CONTRACTOR RESPONSIBLE FOR ENSURING APPROVED DWGS ON SITE AT TIME OF INSPECTION

- A0 TITLE SHEET
- A1 BASEMENT PLAN ELEV. 'A' & 'B'
- A2 GROUND FLOOR ELEV. 'A'
- A3 SECOND FLOOR ELEV. 'A'
- A4 PARTIAL ALT. KITCHEN LAYOUT
- A5 GROUND FLOOR ELEV. 'B'
- A6 SECOND FLOOR ELEV. 'B'
- A7 FRONT ELEVATION 'A'
- ROOF PLAN ELEV 'A'
- A8 RIGHT SIDE ELEVATION 'A'
- A9 REAR ELEVATION 'A' & 'B'
- A10 LEFT SIDE ELEVATION 'A'
- A11 FRONT ELEVATION 'B'
- ROOF PLAN ELEV 'B'
- A12 RIGHT SIDE ELEVATION 'B'
- A13 LEFT SIDE ELEVATION 'B'
- D1 CONSTRUCTION NOTES
- D2 CONSTRUCTION NOTES
- D3 CONSTRUCTION NOTES

Tice River Homes Legacy

BASEMENT PLAN ELEV. 'A' & 'B'

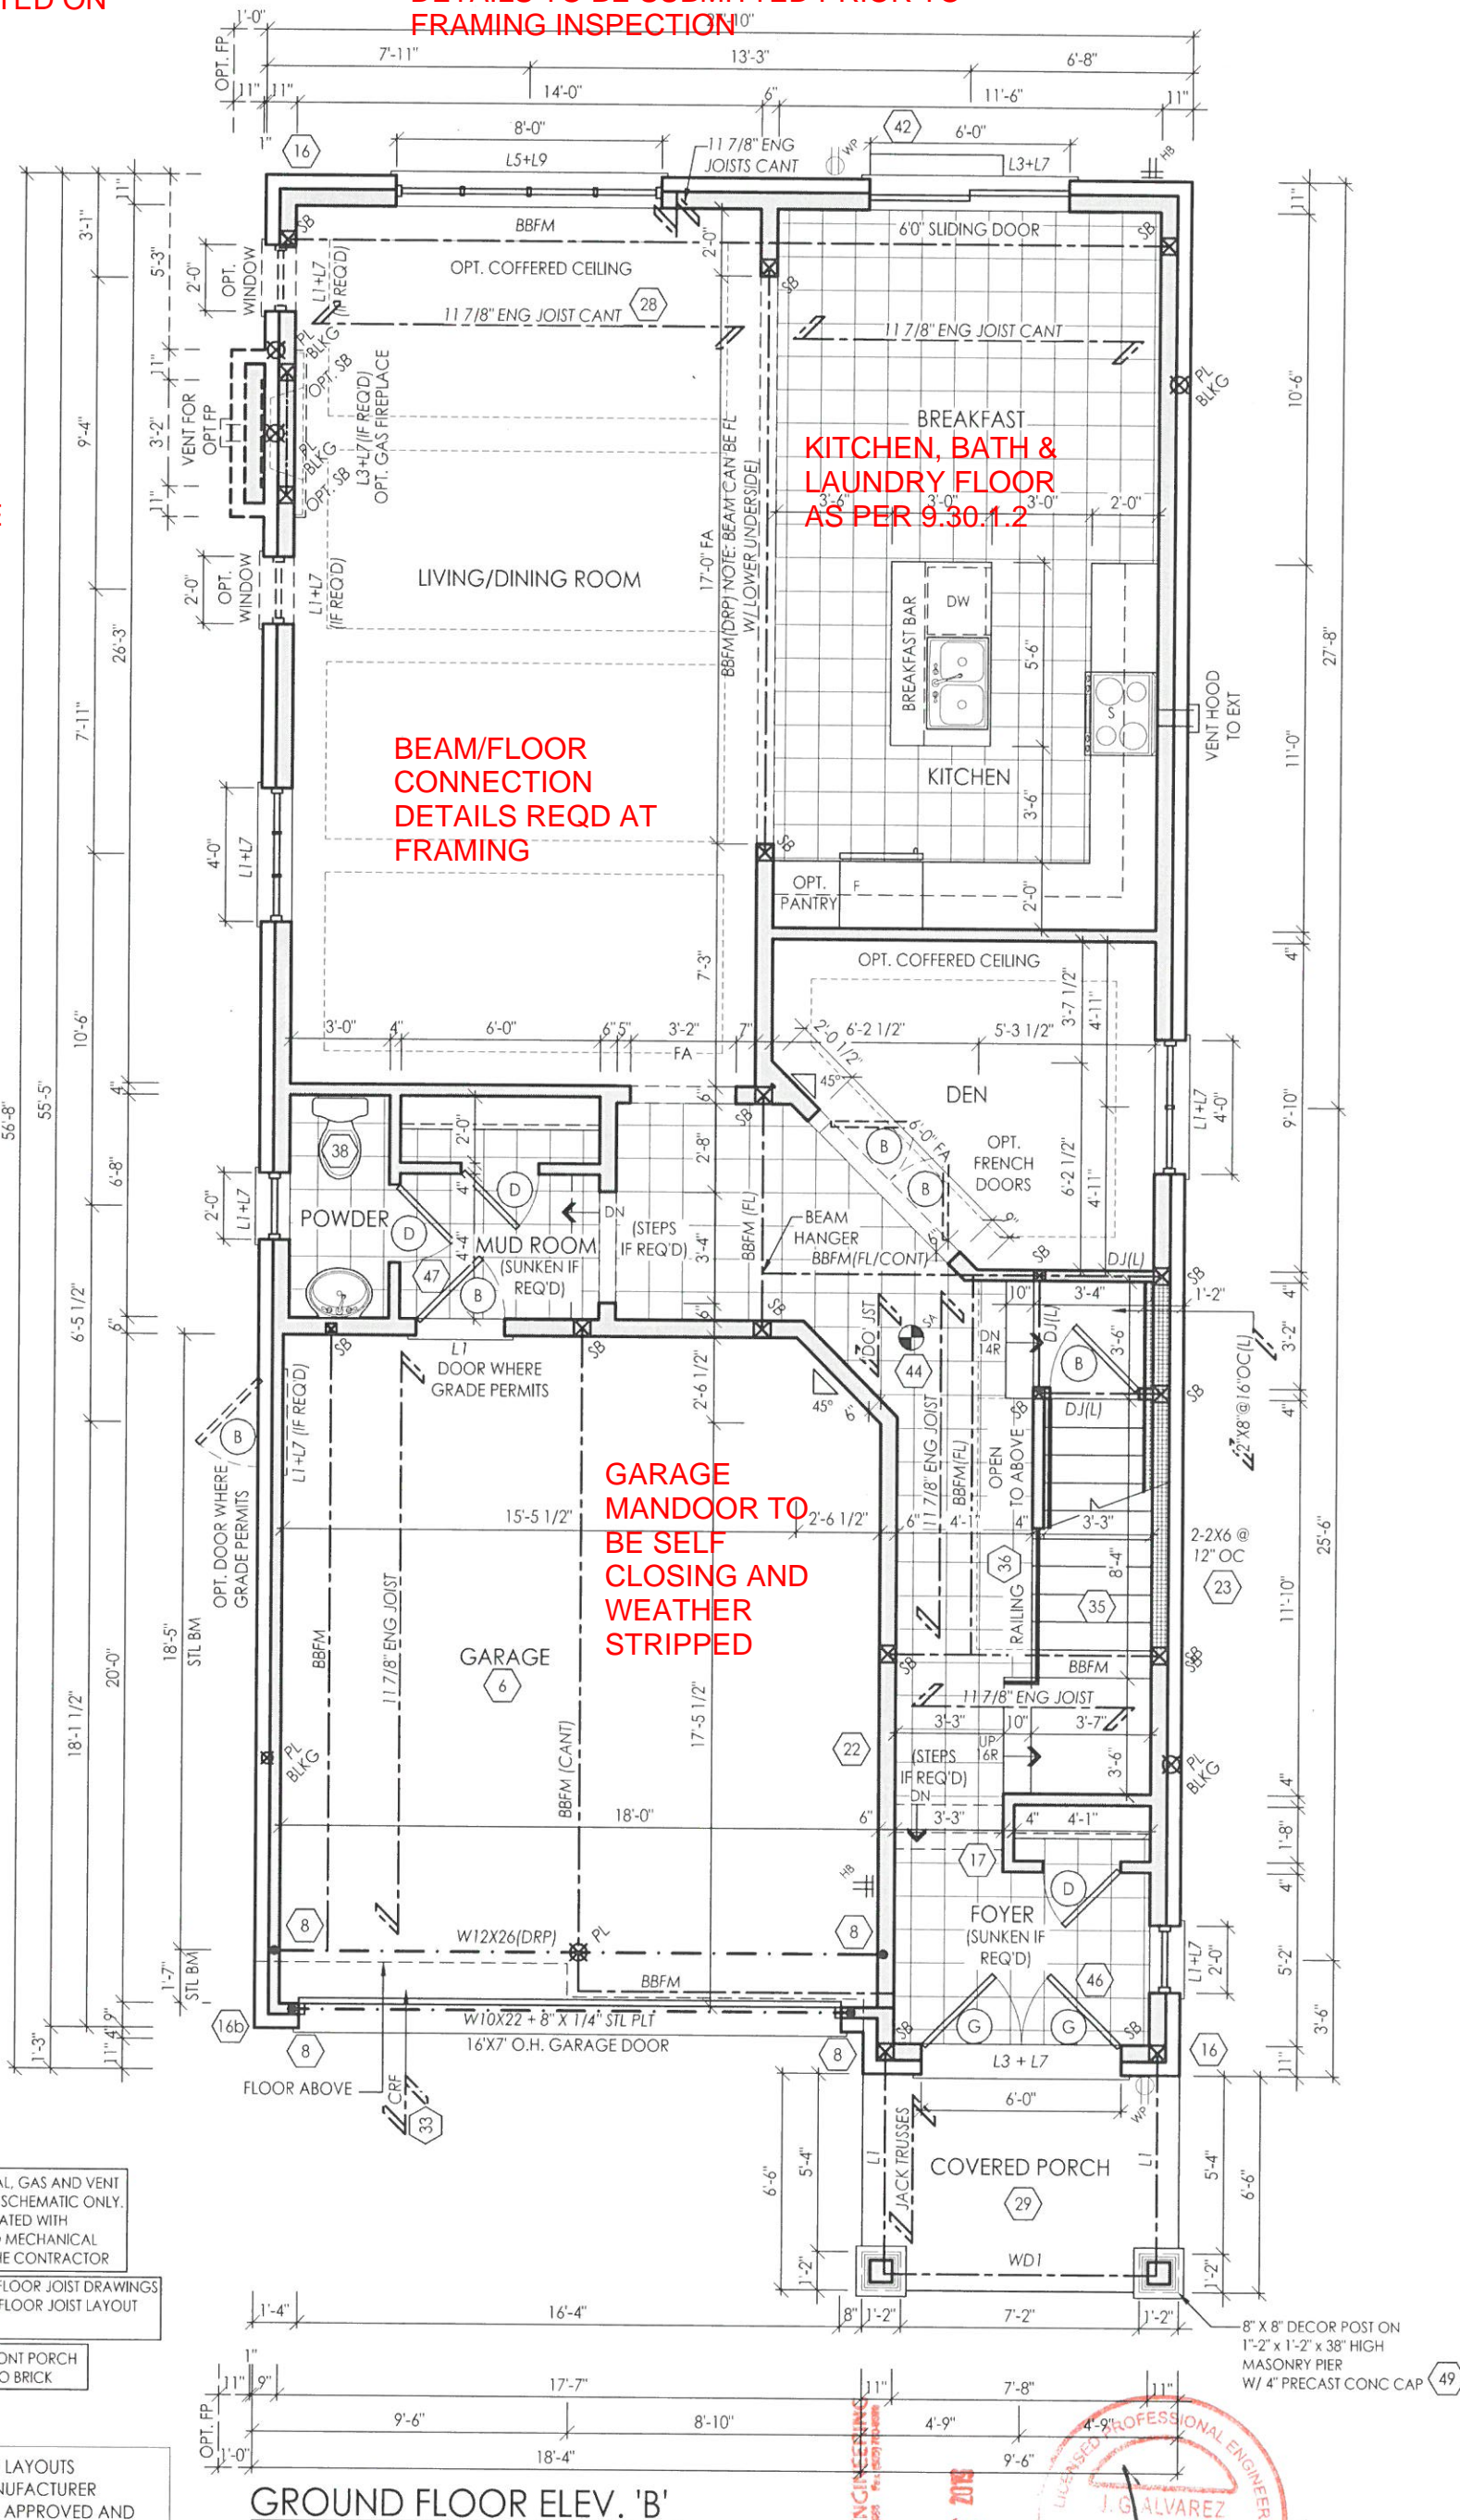
**BASEMENT AIR BARRIER
SUMP LIDS, JOINTS AT
INTERSECTIONS AND ALL
PENETRATIONS OF SLAB
MUST BE SEALED TO
PREVENT AIR LEAKAGE**

**MAX PROJECTION
INTO REQD SIDE
YARD 0.3M**

**6'11 CEILING
HEIGHT REQD
OVER 75% OF BSMT
SPACE AS PER 9.5.3**

**COLD CELLAR
DOOR TO BE
INSULATED AND
WEATHER
STRIPPED**

**CONC PORCH SLAB
AS PER 9.39**

GROUND FLOOR ELEV. 'B'

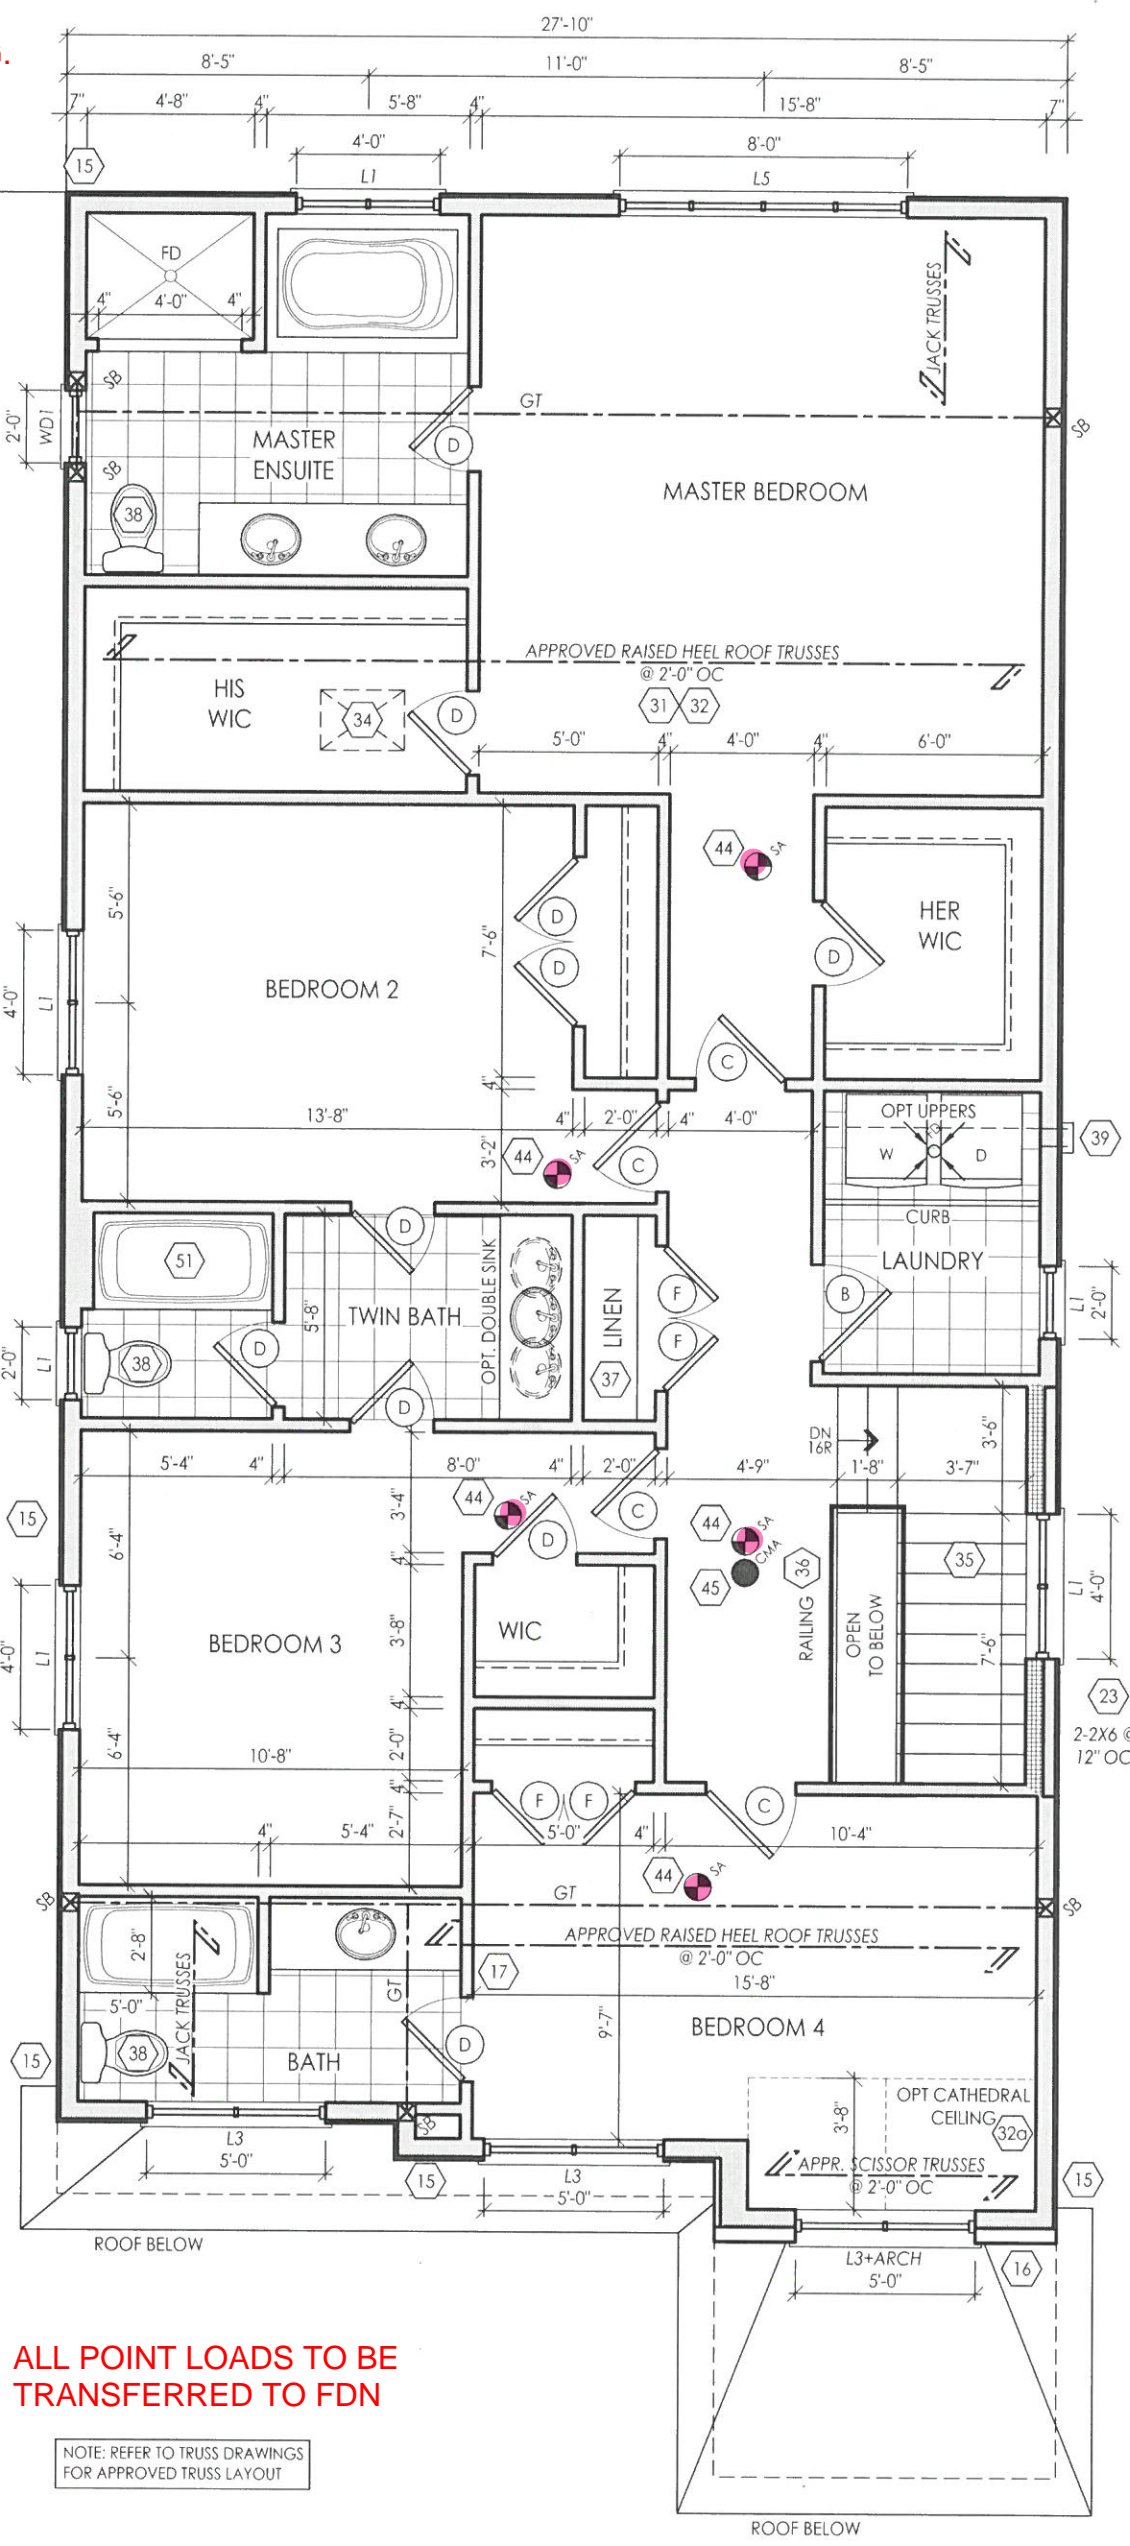
BEAM AND LINTEL
SIZES TO BE NOTED ON
FUTURE PLANS

LINTEL PACKAGE AND ENGINEERED BEAM
DETAILS TO BE SUBMITTED PRIOR TO
FRAMING INSPECTION

MAX
PROJECTION
INTO REQD SIDE
YARD 0.3M

SECOND FLOOR ELEV. 'B'

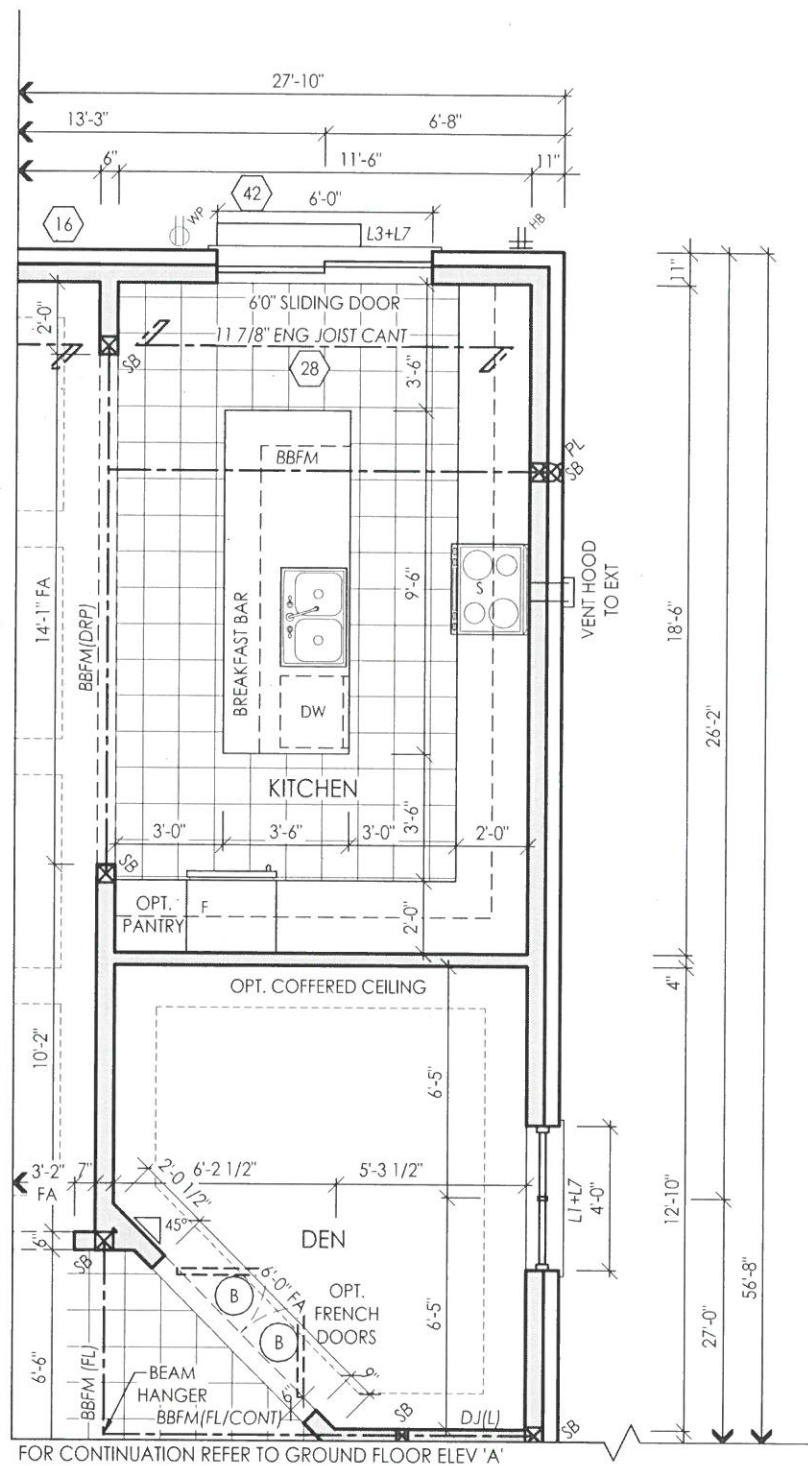
ENGINEERED FLOOR LAYOUT, TRUSSES AND LINTELS TO BE SUBMITTED PRIOR TO FRAMING. DESIGNER TO COMPLETE RESPONSIBILITY REVIEW FORM AND TO BE SUBMITTED WITH TRUSS, FLOOR AND LINTEL DOCUMENTS.

MAIN BATH TO HAVE GRAB BAR BLOCKING

WINDOW ON LANDING MUST BE HIGHER THAN 3' ABOVE OR ENGINEERING ON WINDOW OR GUARD REQD

ALL POINT LOADS TO BE TRANSFERRED TO FDN
